ADDENDUM NO. 3 TO PROJECT NO. 44782

ELECTRICAL WORK PROVIDE FIRE ALARM AND EMERGENCY VOICE EVACUATION SYSTEM EMPIRE STATE PLAZA ALBANY, NY 12242

May 2, 2025

DRAWING NUMBER:
F-C-114

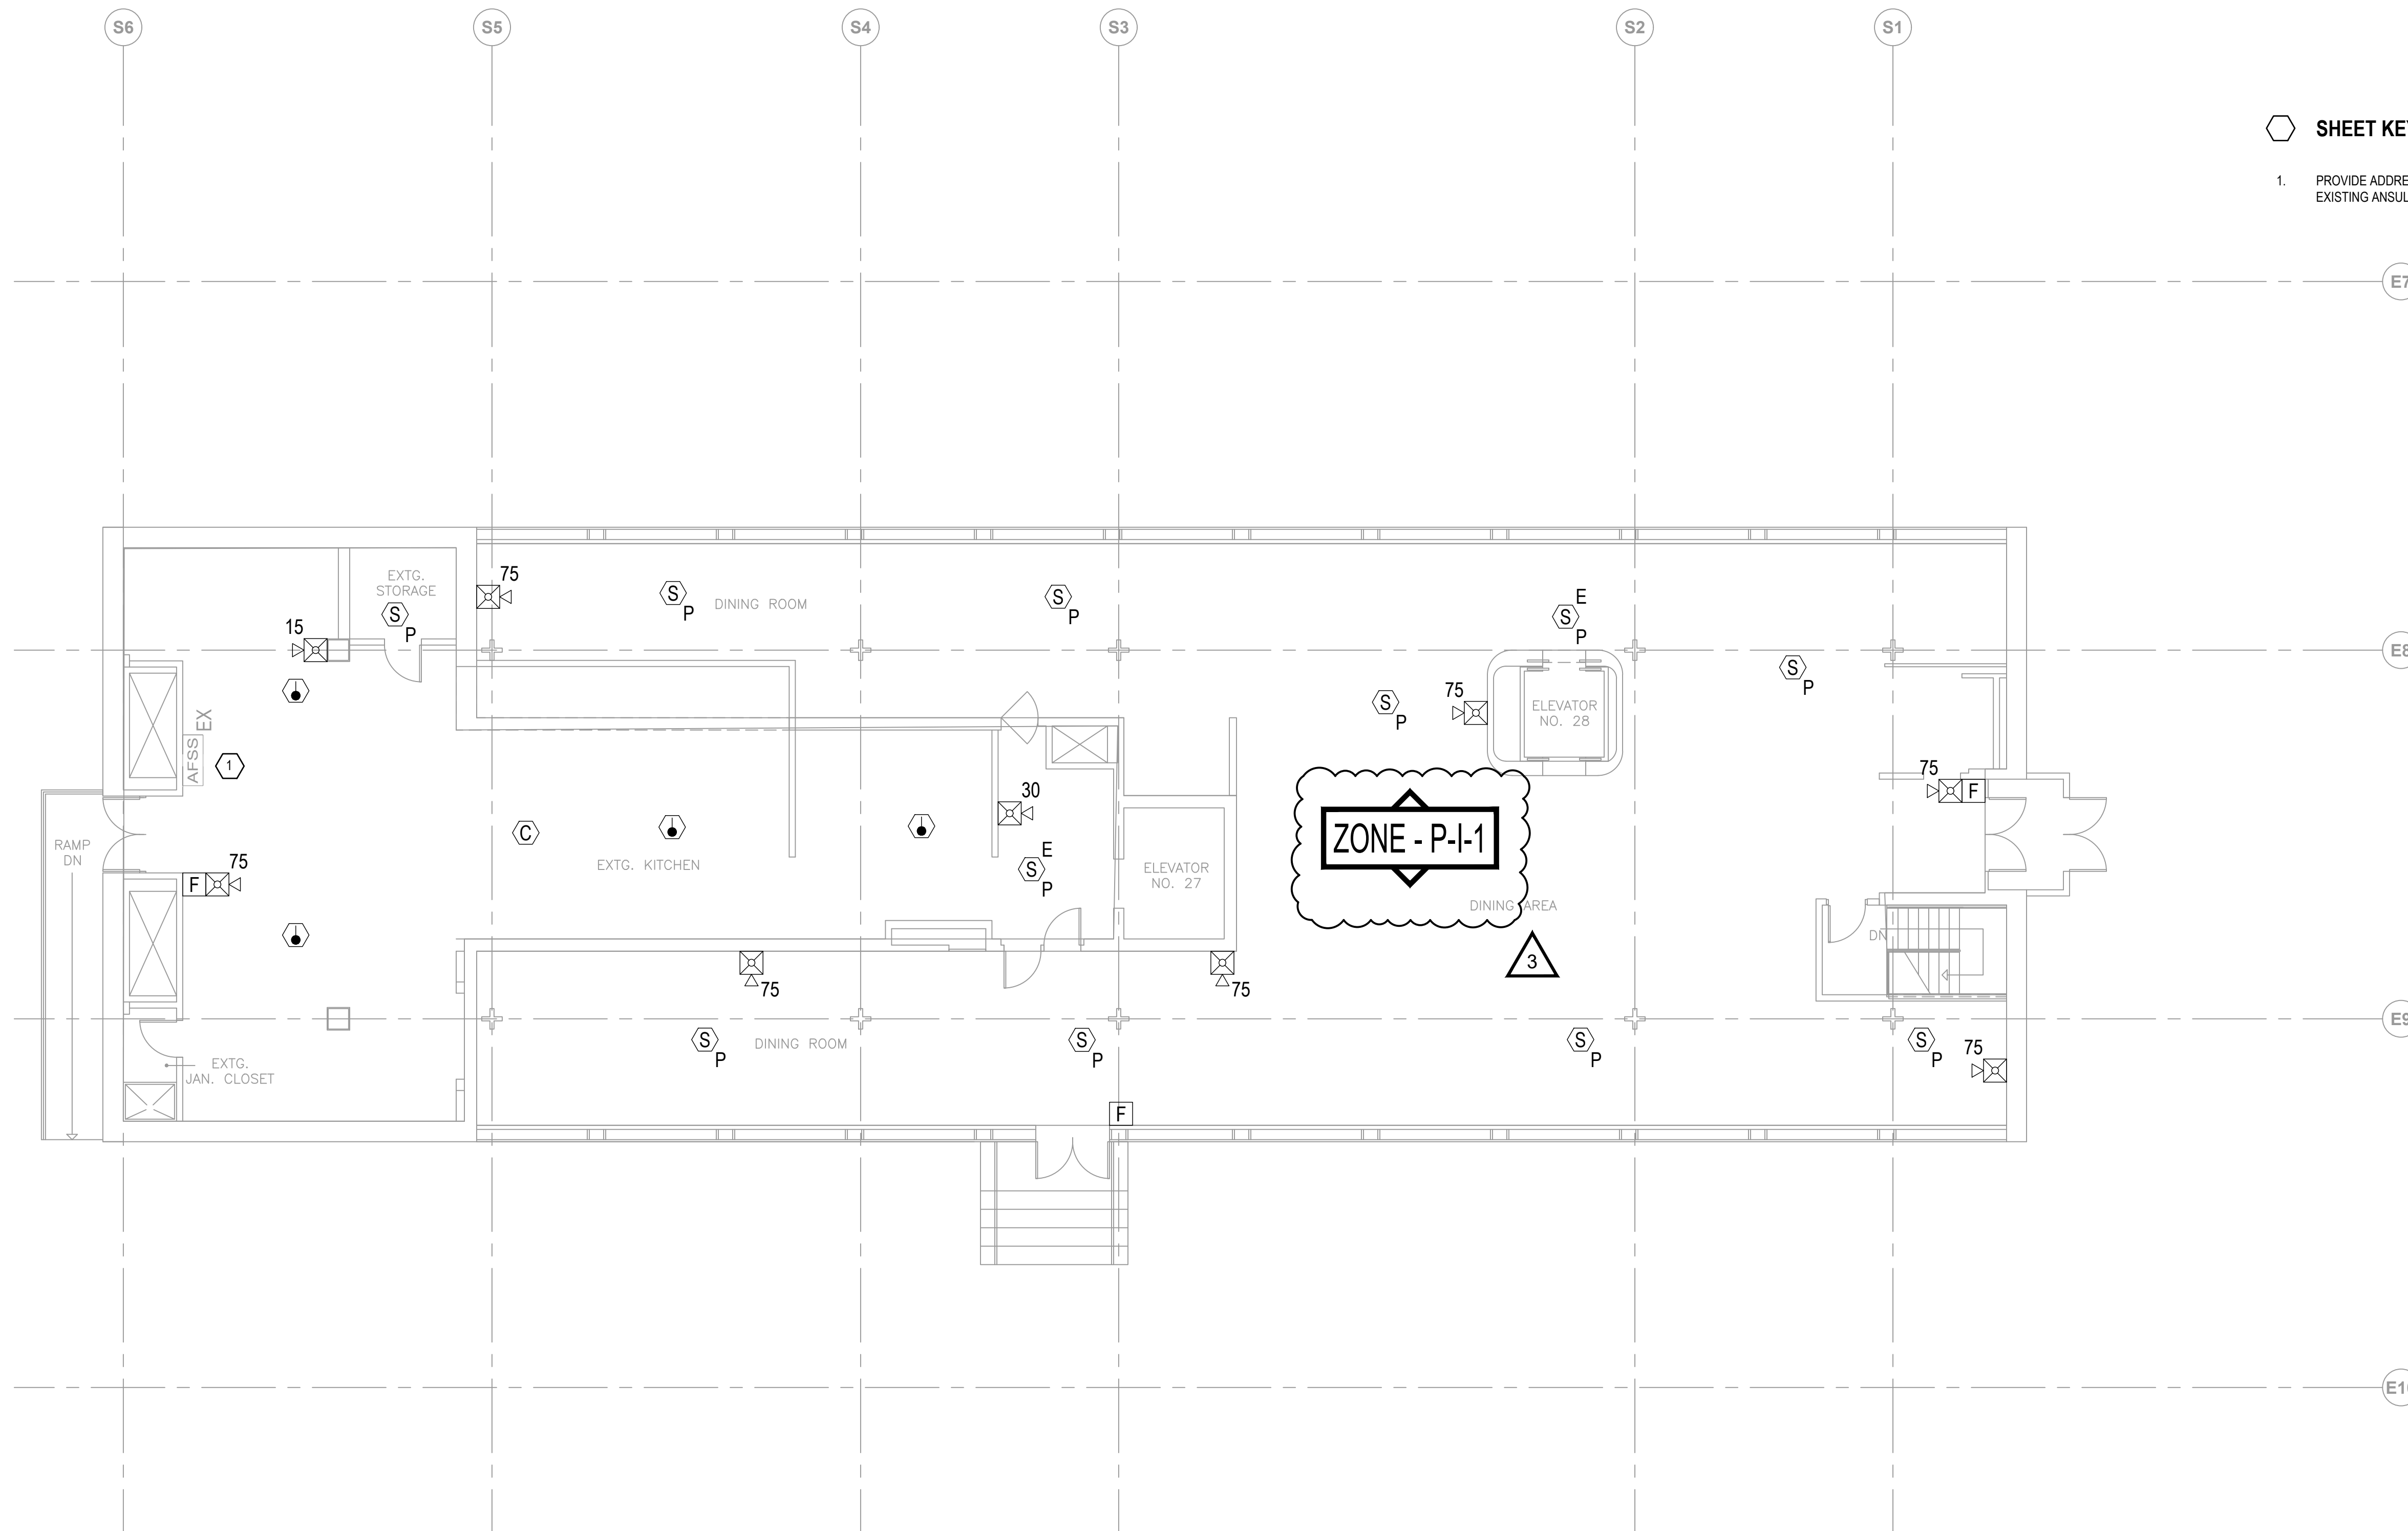
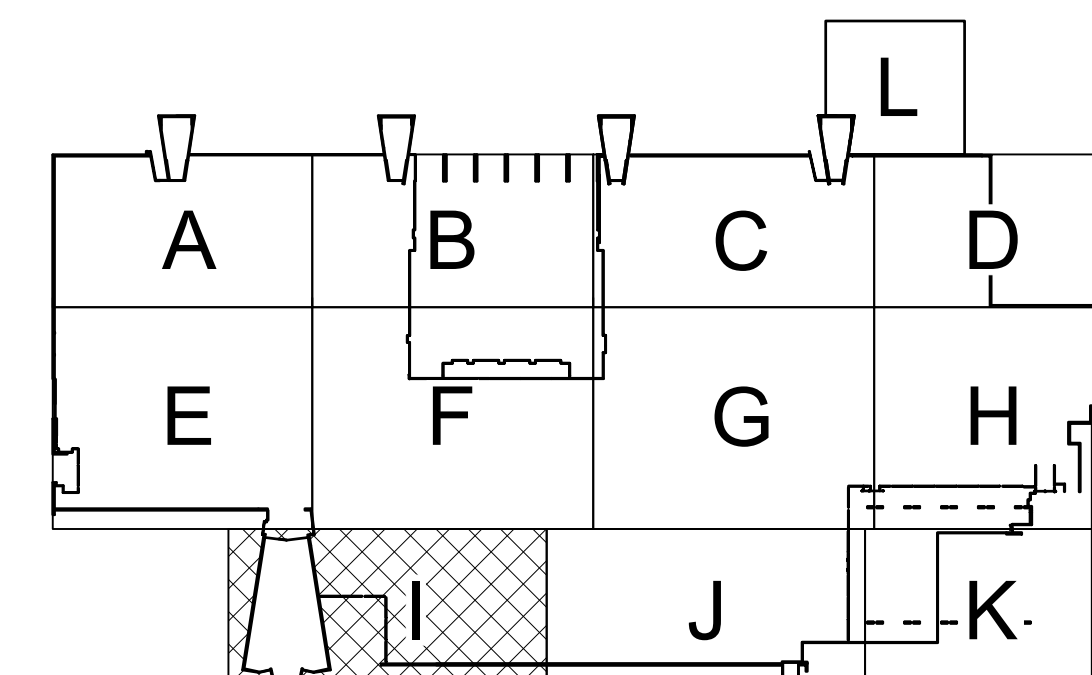
1. PROVIDE ADDRESSABLE INPUT MODULE FOR MONITORING OF THE EXISTING ANSUL KITCHEN AUTOMATIC FIRE SUPPRESSION SYSTEM.

SHEET TITLE:
MEZZANINE LEVEL CORNERSTONE AREA I FLOOR PLAN
DRAWING NUMBER:
F-C-115
SHEET 125 of 137

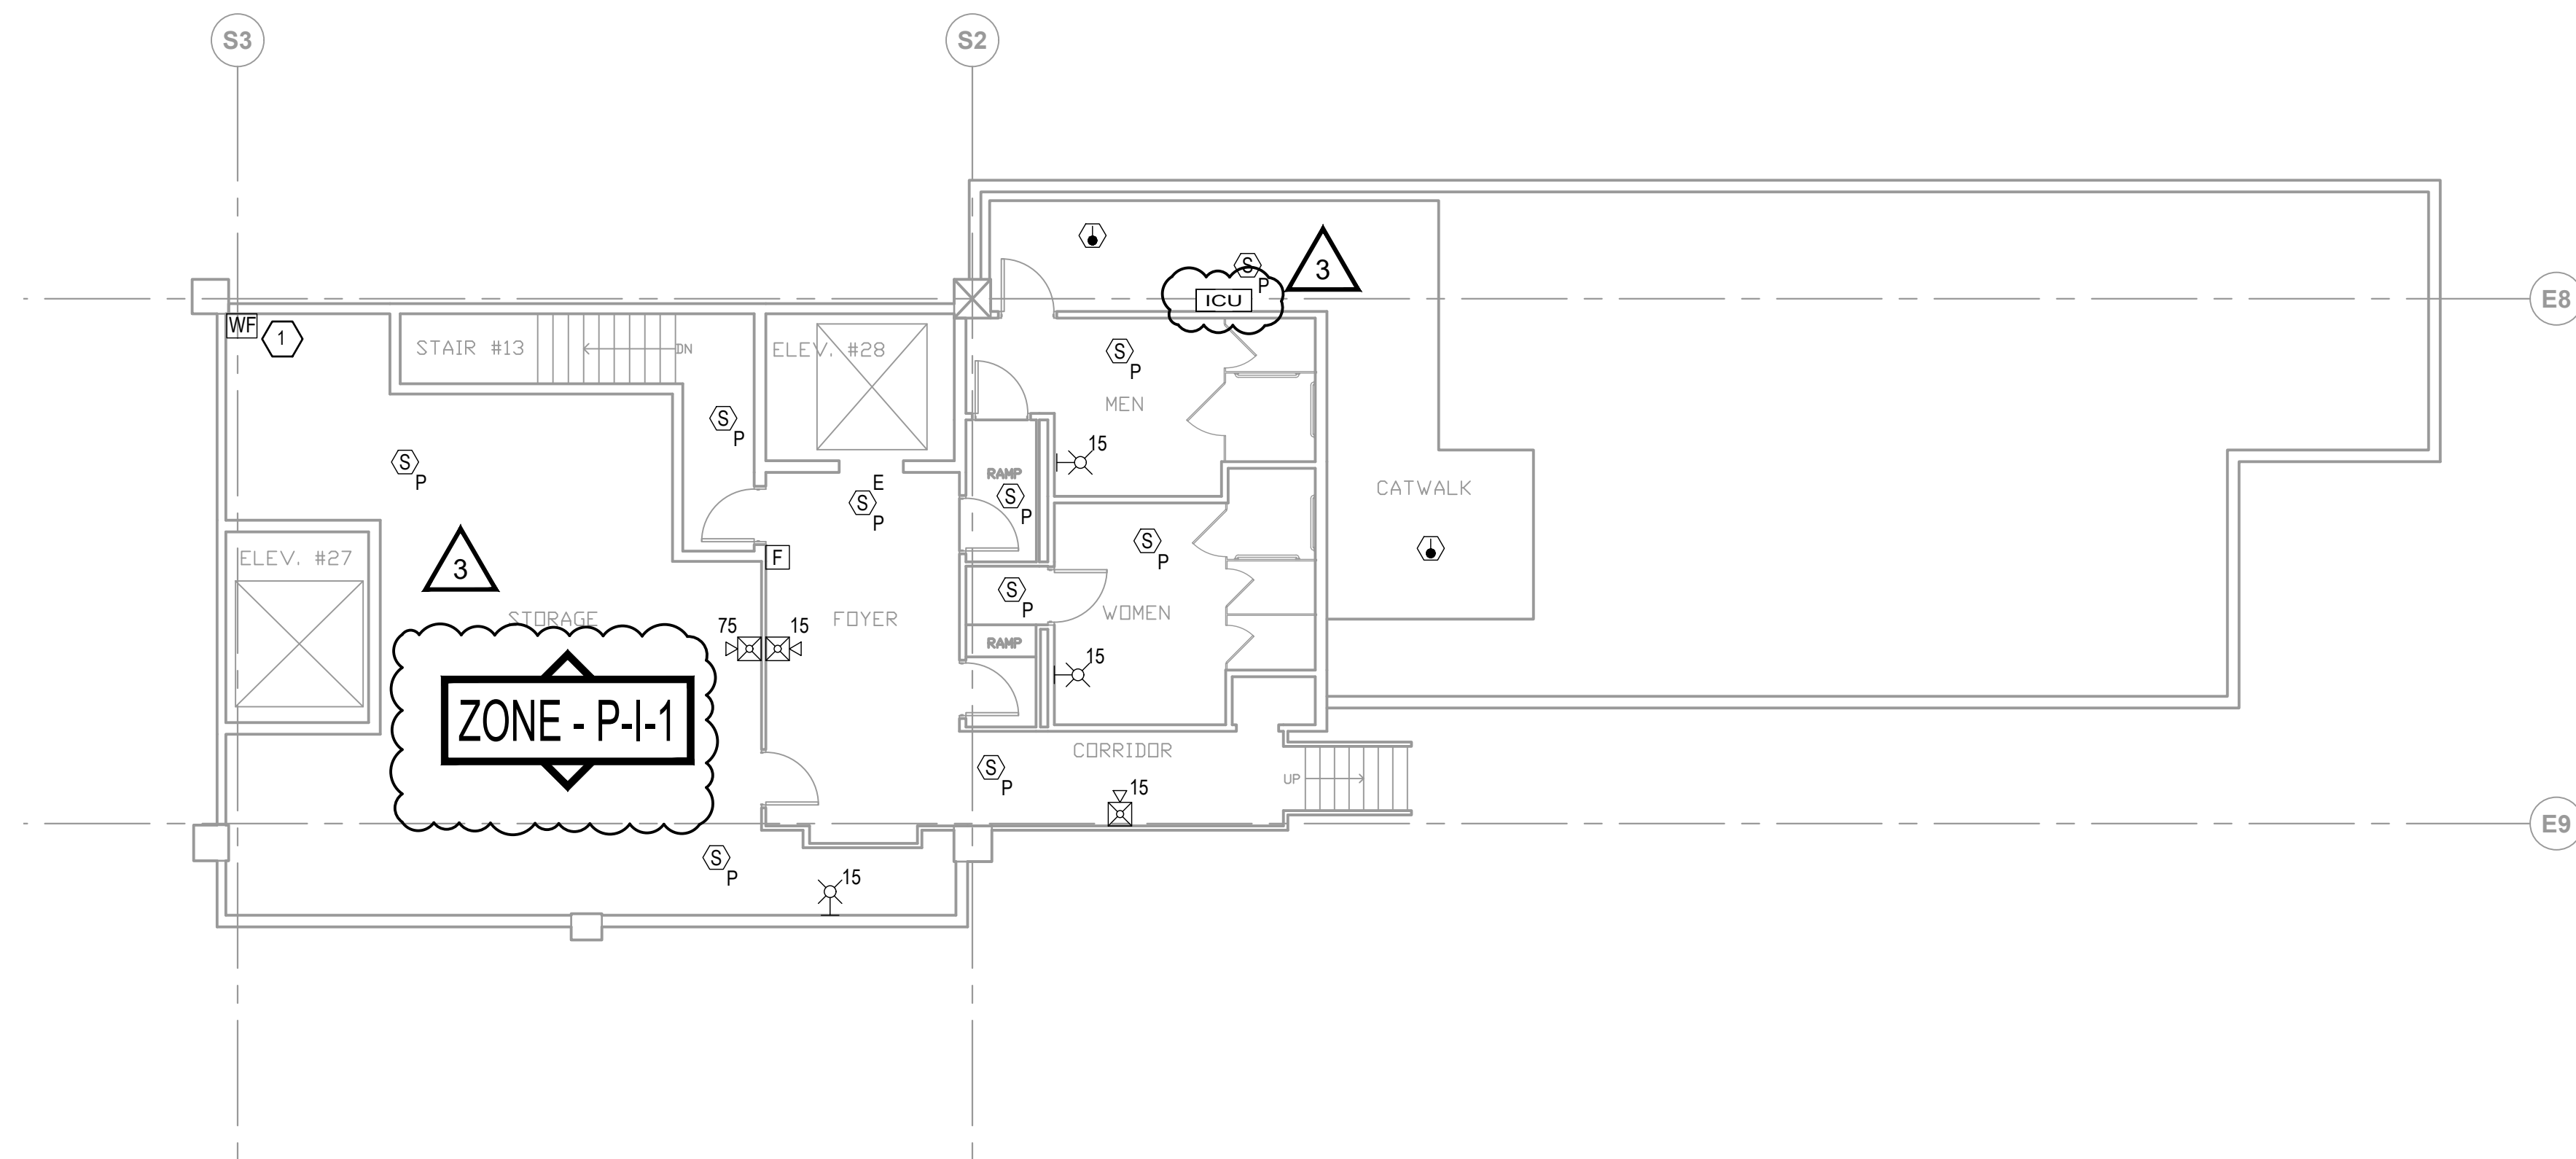
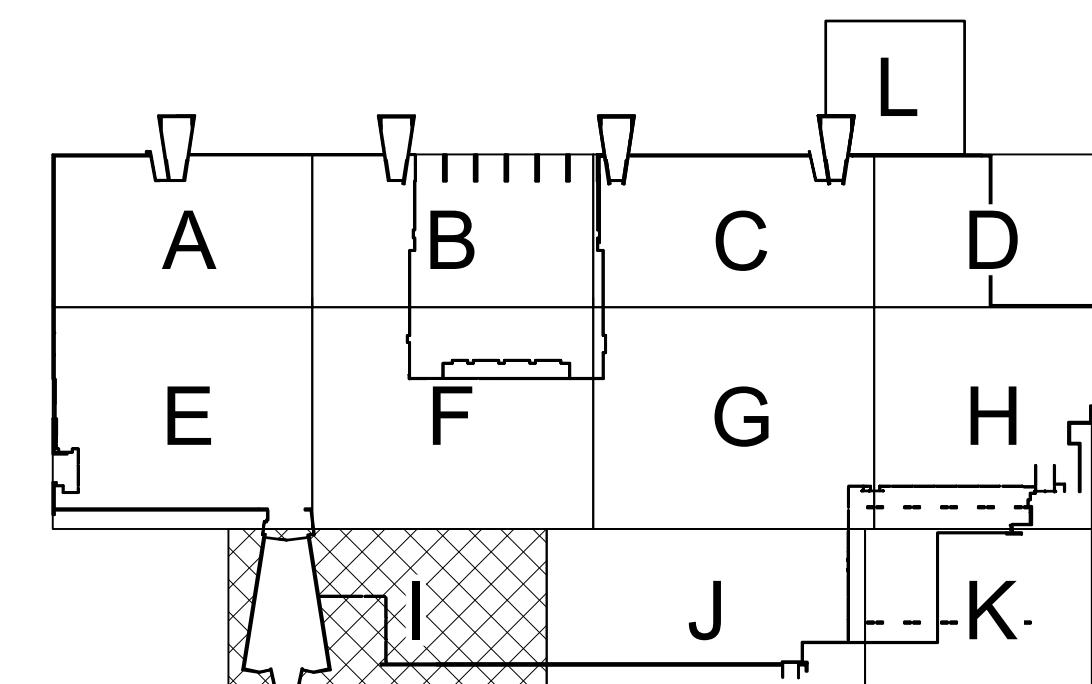
1. PROVIDE ADDRESSABLE INPUT MODULE FOR MONITORING OF THE EXISTING WATERFLOW SWITCH.
